# AMF HARLEY-DAVIDSON SERVICE BULLETIN

No. 663

### CLUTCH CHANGES / 1974 XL, XLCH

#### CLUTCH CONVERSION KIT/XL, XLH, XLCH

FIGURE 4-6B

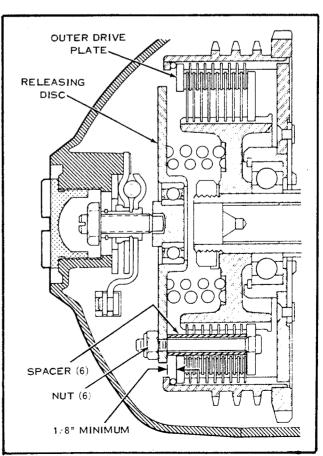
Also check to see that between 5/32 and 7/32 distance is obtained between inner surface of releasing disc and inside surface of outer drive plate. Under no circumstances should this distance between plates be less than 1/8 inch as shown in Figure 4-6B of Service Manual.

NOTE: Kit contains standard spacers, part No. 5995, which are 1.530 in. long. Shorter spacers are available to reduce distance, thereby increasing clutch spring tension as follows: spacer, part No. 5996 length 1.490 long and spacer, part No. 5997 length 1.450 long.
